Project	IEEE 802.16 Broadband Wireless Access Working Group http://ieee802.org/16 >
Title	Fixes for Network Entry Flow Charts
Date Submitted	2006-09-26
Source(s)	Nadav Lavi et al Alvarion Ltd. [Address Line 1] [Address Line 2] Voice: +97236457834 Fax: [Fax Number] [mailto:Nadav.lavi@alvarion.com]
Re:	
Abstract	Fixes for Network Entry Flow Charts in 802.16e
Purpose	For the review in 802.16 Maint TG
Notice	This document has been prepared to assist IEEE 802.16. It is offered as a basis for discussion and is not binding on the contributing individual(s) or organization(s). The material in this document is subject to change in form and content after further study. The contributor(s) reserve(s) the right to add, amend or withdraw material contained herein.
Release	The contributor grants a free, irrevocable license to the IEEE to incorporate material contained in this contribution, and any modifications thereof, in the creation of an IEEE Standards publication; to copyright in the IEEE's name any IEEE Standards publication even though it may include portions of this contribution; and at the IEEE's sole discretion to permit others to reproduce in whole or in part the resulting IEEE Standar

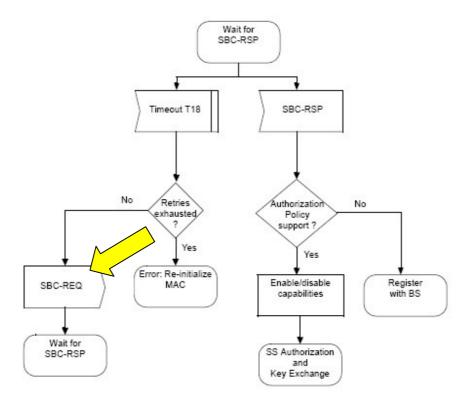
- 1. There is an unclear definition of how to handle expiration of T9 in the BS side in SBC transaction, and expiration of T17 in the BS side in REG transaction. The condition for "Release and age-out connections" is unclear and not well defined. In addition, this action is local to the BS and thus remains unknown to the SS. We suggest that the BS would send unsolicited RNG-RSP message with Abort instruction when these timers expire.
- 2. The current Network Entry flow chart cannot handle retransmission, either due to processing delays or message drop. After the BS transmits a response message, it will proceed directly to the next state in the Network Entry flow and thus cannot handle a retransmission of request by the SS; this would cause the Network Entry procedure to end in failure. For example, the following flow chart (Figure 67 in 802.16e-2005) shows that BS sends SBC-RSP.

Replace Figure 67 in 6.3.9.7 with the following figure:

Figure 70—Registration—BS

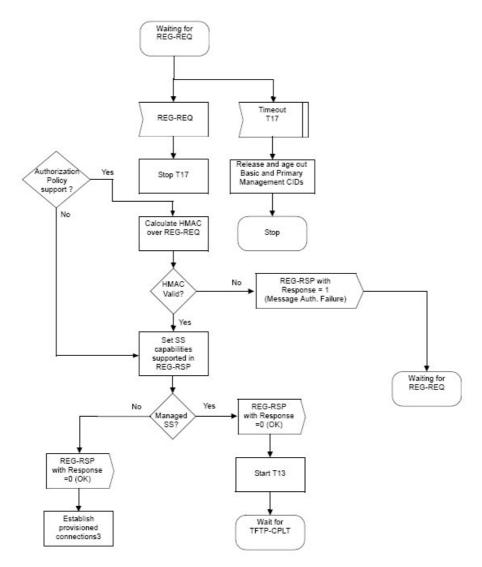
However after sending SBC-RSP, the BS proceeds directly to the registration step. The corresponding flow chart (Figure 70) does not contain any state where a retransmission of SBC-REQ can be received and processed. This is just an example of one single scenario. Similar failures can be identified for other steps in the entire Network Entry flow.

Replace Figure 70 in 6.3.9.9 with the following figure:

Figure X – Network entry state-machine BS side (Applies only to OFDMA)

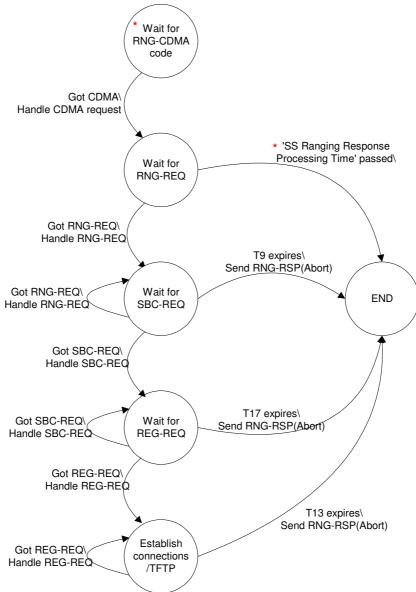
Add the following Figure:
